Ben Allison Park

Ben Allison Park is small neighborhood park that provides a sledding hill, ballfield, playground and walkway. The main issues at this park are providing accessible routes, slopes too steep, protruding branches, clear floor space at elements, accessible picnic table and accessible grill. **Please Note:** When a **UD** is indicated, this is a Universal Design (**UD**) recommendation to enhance accessibility. The **UD** recommendation is not required to meet the minimum accessibility standards but it would be encouraged.

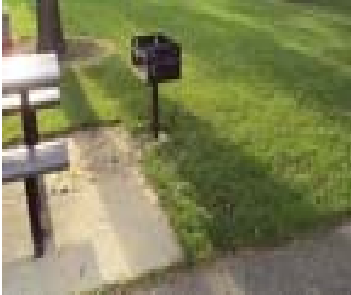
The branch of the maple tree on the walkway to the playground protrudes at 75".	ADAAG 307	Trim the branch to provide an 80" minimum clear head space and back to the edge of the walkway.			\$50	2012	Staff trimmed branch 4/12
